## **REMEDIATION SYSTEM EVALUATION (RSE)**

### **NORTHWEST PIPE AND CASING SITE CLACKAMAS, OREGON**

Report of the Remediation System Evaluation  
Site Visit Conducted May 9, 2007

Final Report  
September 2007

Figure 1-2. Water Levels in Shallow Water Bearing Zone

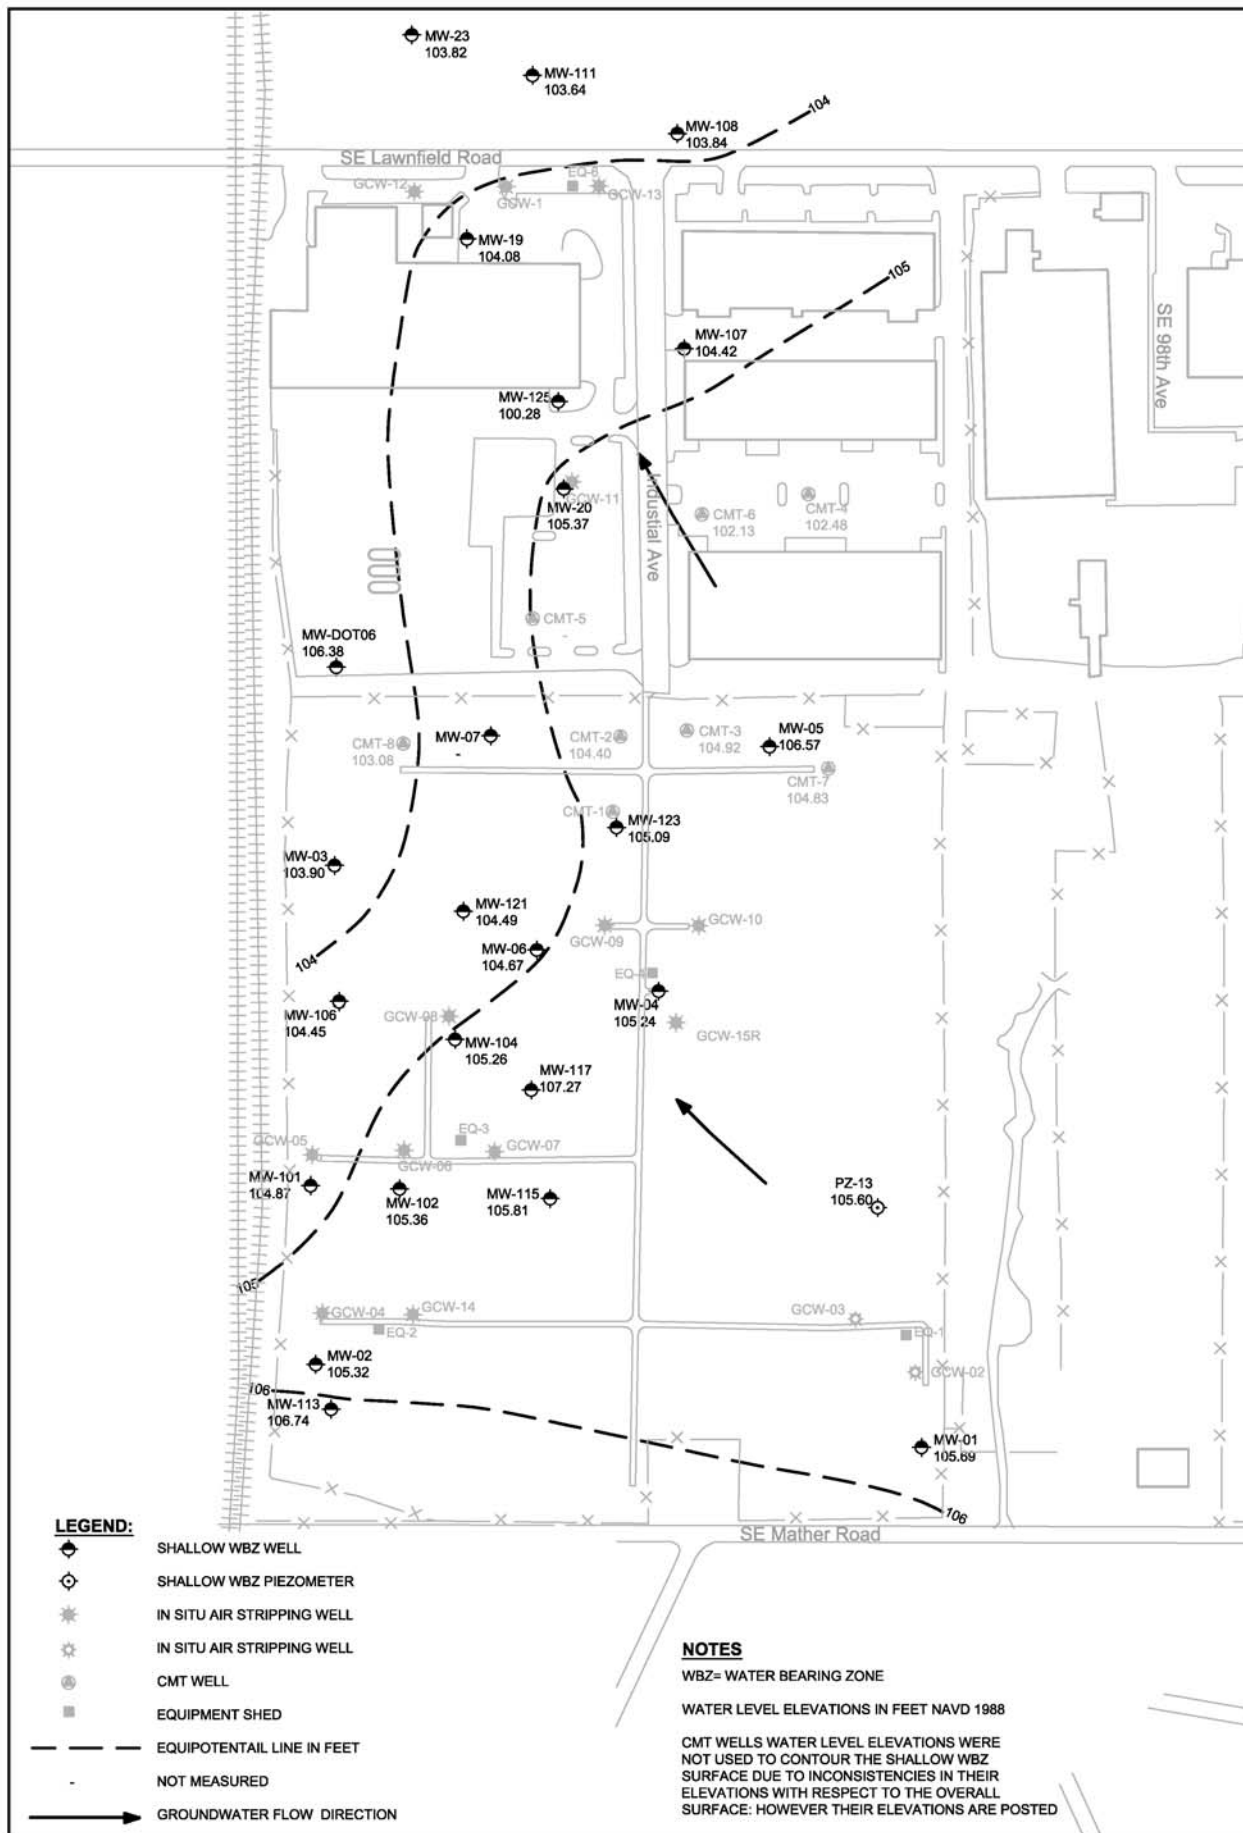
The RSE team notes that the water level maps presented in Figures 1-2 and 1-3 do not indicate any substantial hydraulic impact from the GCWs. Water is extracted from the shallow screen and recirculated to the deep screen, but there are no obvious cones of depression in the Shallow WBZ, and no apparent mounding in the Intermediate WBZ, in the vicinity of the GCWs.

Figure 1-4. Total Concentration of PCE, TCE, and VC in Shallow Water Bearing Zone

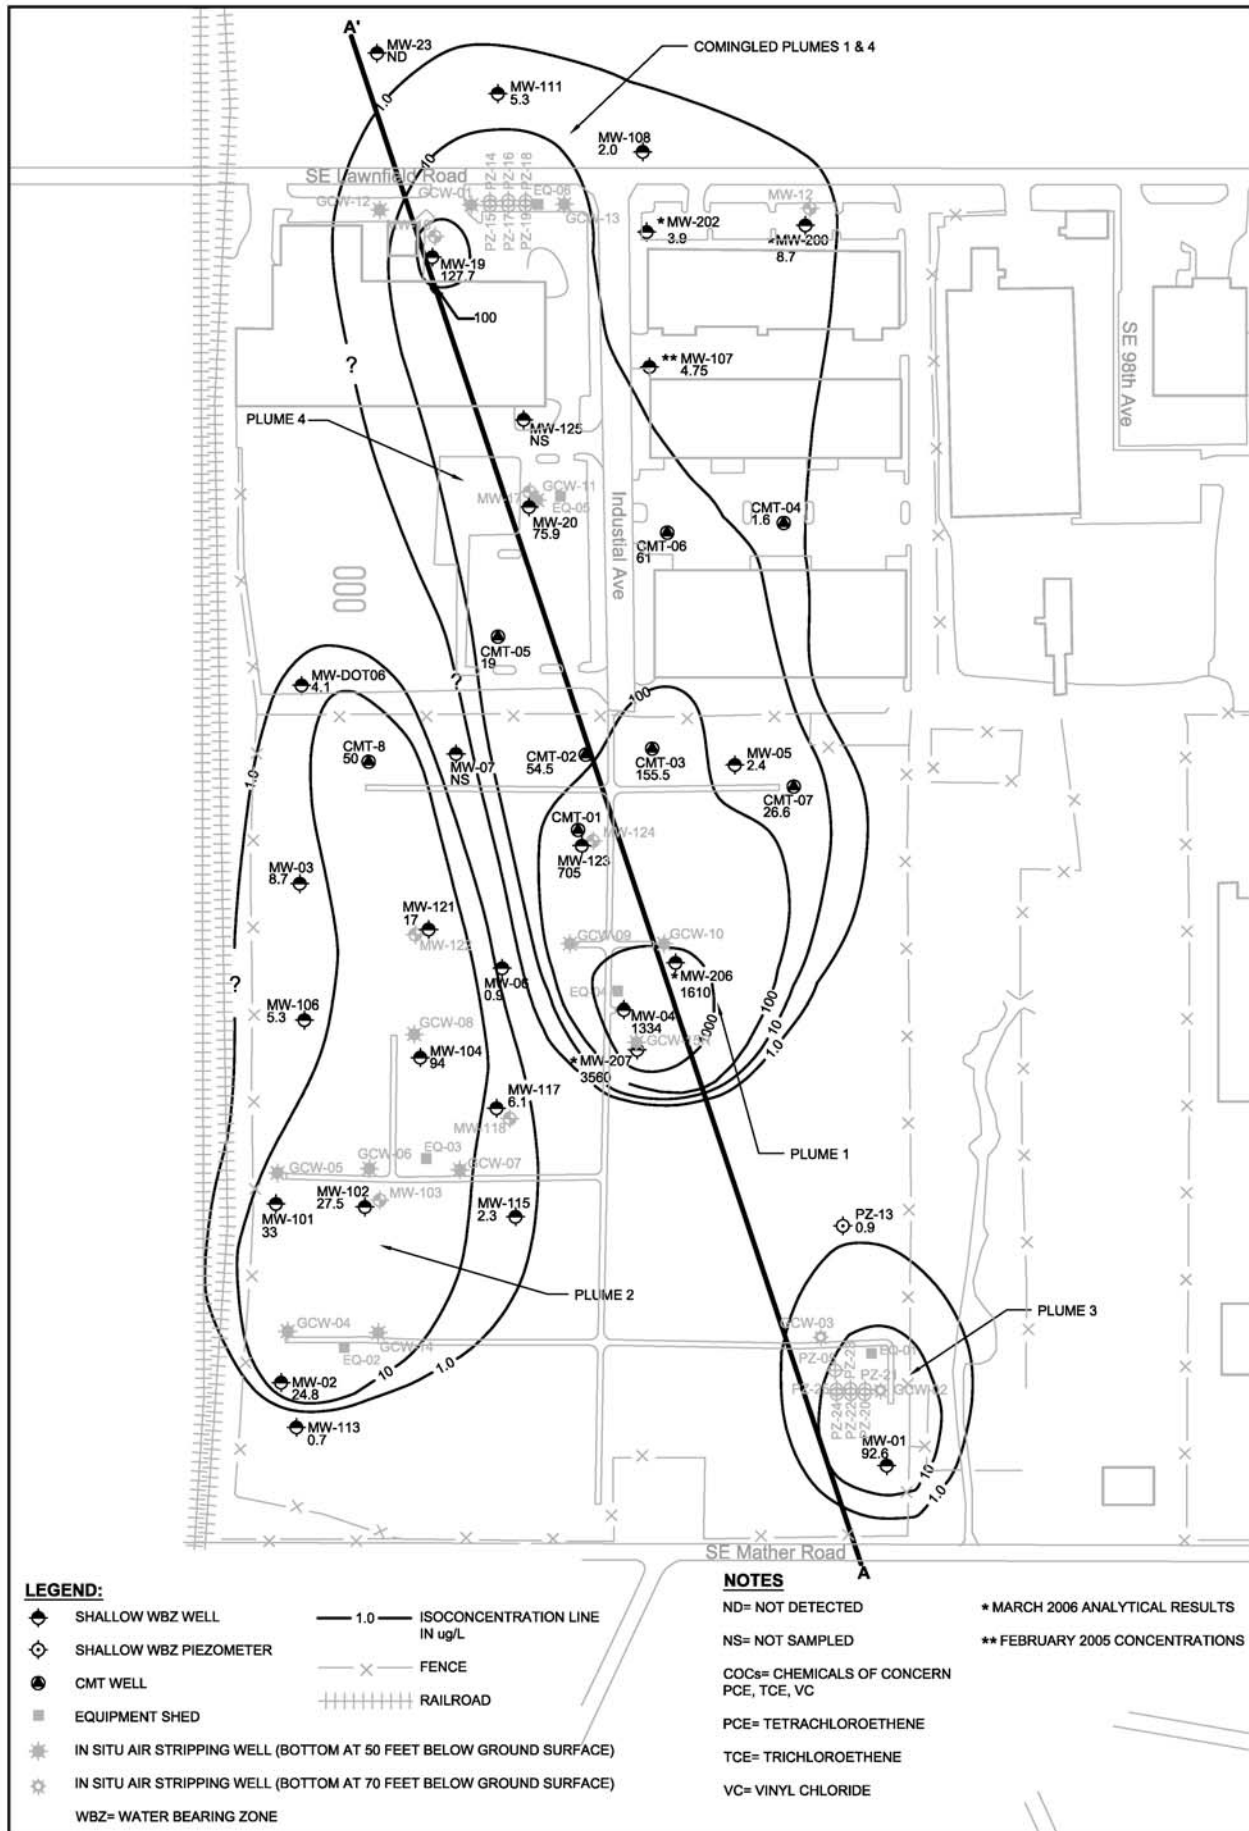
Inspection of Figure 1-4 indicates that the highest Total COC concentrations (i.e., greater than 1,000 ug/l) are observed in the Shallow WBZ at MW-04, MW-206, and MW-207. However, there are no permanent monitoring points located immediately south of these wells, and therefore the extent of this “core area” of higher concentrations cannot be easily determined. This is important because consideration of more aggressive measures for reductions of the highest concentrations at the site (such as chemical oxidation or enhanced in-situ bioremediation) has been suggested by Parametrix, and is also recommended by the RSE team (see Section 6.4). The implementation and cost of these more aggressive approaches will depend on the size of the “core area” of highest concentrations. Therefore, unless the site team has information from other previous direct-push investigations that clarifies the delineation in this area, the RSE team recommends that an investigation be performed in the area south of the three wells listed above, in the Shallow WBZ, using direct push techniques or temporary wells installed with rotosonic drilling. It was stated during the RSE site visit that direct push techniques can be problematic at this site due to angular gravels, and the RSE team defers to the site team to select the appropriate technology. Assuming a brief work plan, up to two days of drilling work in the Shallow WBZ, analysis of up to 10 samples for VOCs, and a brief report summarizing results, a cost of approximately \$30,000 is estimated.
